## Suspension - Air Suspension Height Sensor Linkage Loose

TSB 06-15-10

### AIR SUSPENSION PERFORMANCE - HEIGHT SENSOR LINKAGE ARM DISENGAGING

FORD:  
2003-2006 Expedition

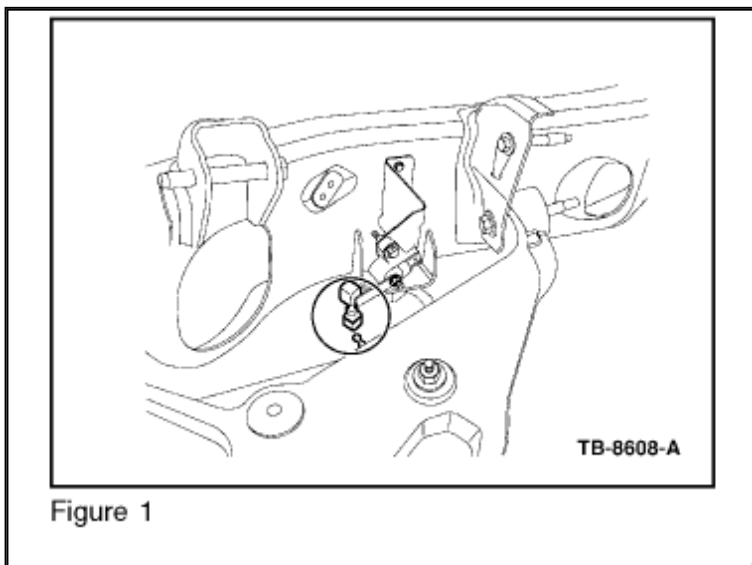
Some 2003-2006 Expedition and Navigator vehicles equipped with an air suspension may exhibit an air suspension height sensor linkage arm disengaging from the suspension ball stud or height sensor rotating arm. This concern typically occurs with the rear sensor (Figure 1) but may occur with the front sensors as well. If this occurs, the symptom will typically be the vehicle leaning to one side, the vehicle sitting too low/high, a harsh ride, and/or an inoperative air suspension. In addition, this concern may result in diagnostic trouble code (DTC) C1725 (air suspension front pneumatic failure) or C1726 (air suspension rear pneumatic failure).

When a linkage arm becomes disengaged, do not re-attach the arm and do not replace the sensor unless broken. Instead, install a revised linkage arm on all three (3) sensor assemblies, even if they have not detached from the ball stud.

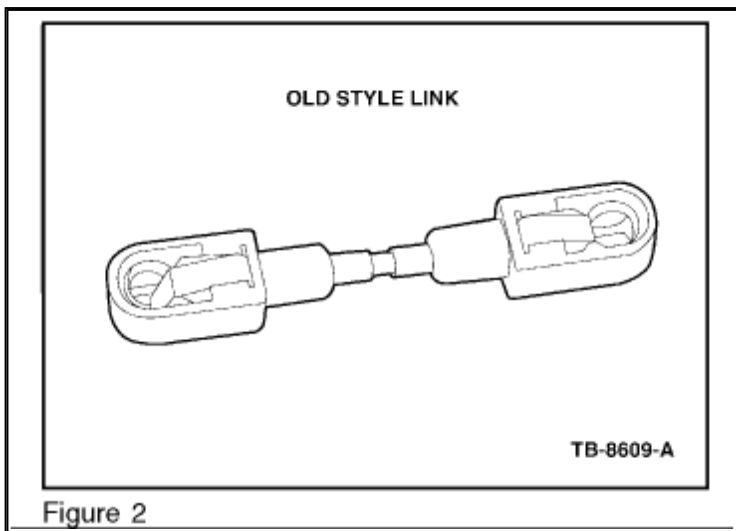
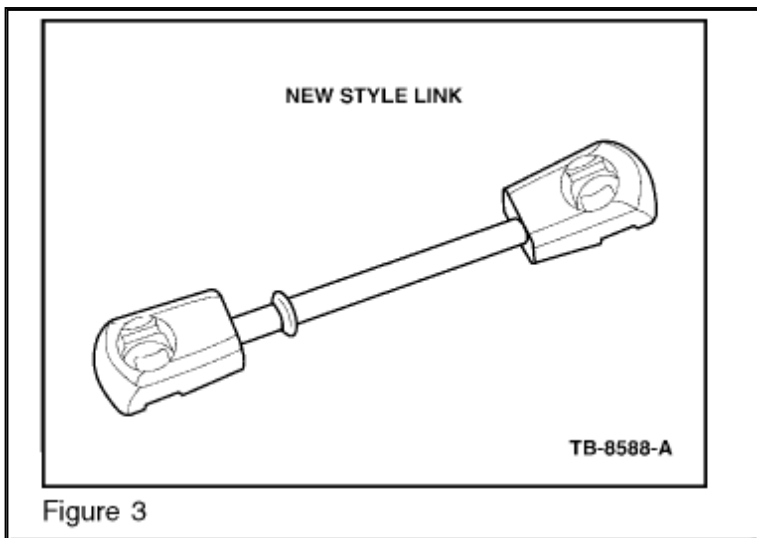
**NOTE** LINKAGE ARMS USED AS ORIGINAL EQUIPMENT ARE SHOWN IN FIGURE 2. REVISED LINKAGE ARMS (FIGURE 3) HAVE A NEW DESIGN THAT MAKES IT MORE DIFFICULT TO DISENGAGE FROM THE BALL STUDS.

1. Replace linkage arms on all three (3) sensor assemblies following Workshop Manual (WSM), Section 204-05.
2. Discard the old linkage arms.
